Access Compliance Report

Public Rights-of-Way

Intersection ID: 52550	Main Street: MEADOW_BOTTOM_RD	Cross Street: KRISTENS_MARE_DR	Location: SW
ADA ID: 562388346FE1	Ramp Type: PerpDiag	Initial Pass/Fail: Pass	Overall Compliance: No
Severity Score: 5			
Codes/Mitigation Info/Possible Solution		Field Measurements/Component Compliance

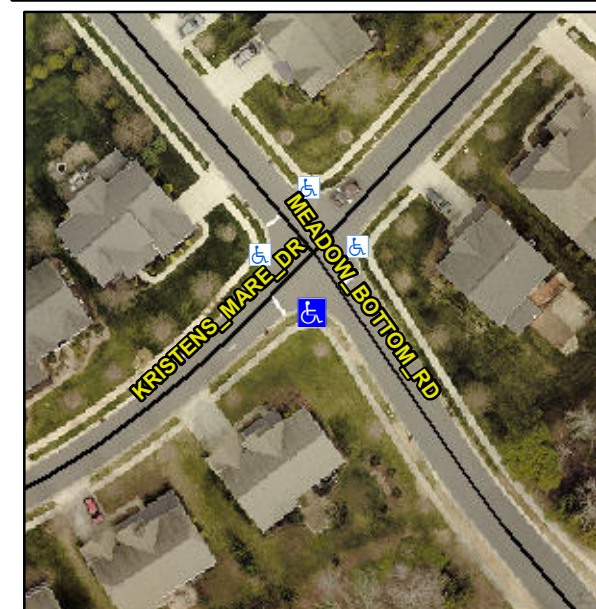
Not Found, R304.5.3, R304.5.4

Compliance	Description	Data	Compliance	Description	Data
N/A	Ramp Length (in)	49.0	Yes	Ramp Slope (%)	6.1
Yes	Ramp Width (in)	48.0	Yes	Ramp XSlope (%)	0.9
N/A	Flare Type LT	Sloped	N/A	Flare Type RT	N/A
N/A	Flare Slope LT (%)	2.4	Yes	Flare Slope RT (%)	7.3
N/A	Flare Traversable LT?	Yes	N/A	Flare Traversable RT?	Yes
Yes	Landing Length (in)	48.0	Yes	DWS Provided?	Yes
Yes	Landing Width (in)	48.0	Yes	DWS Contrast?	Yes
Yes	Landing Slope (%)	1.3	Yes	DWS Length (in)	24.0
No	Landing X Slope (%)	3.2	Yes	DWS Full Width?	Yes
N/A	Landing Curb? (Y/N)	No	Yes	DWS Offset (in)	2.0
N/A	Shared Landing?	No			
Yes	Gutter Ponding?	No	No	Gutter Slope (%)	13.5
Yes	Gutter Lip Ht (in)	0.0	Yes	Gutter X Slope (%)	1.8
N/A	Painted X Walk1?	No	N/A	Painted X Walk2?	No
	X Walk 1 Direction	To NE		X Walk 2 Direction	To NW
N/A	X Walk 1 Width (in)	N/A	N/A	X Walk 2 Width (in)	N/A
	X Walk 1 Slope (%)	2.5		X Walk 2 Slope (%)	5.5
	X Walk 1 X Slope (%)	3.9		X Walk 2 X Slope (%)	1.4

Remove & Replace Curb Ramp With Two New Directional Ramps or Equivalent. Remove & Replace Gutter.
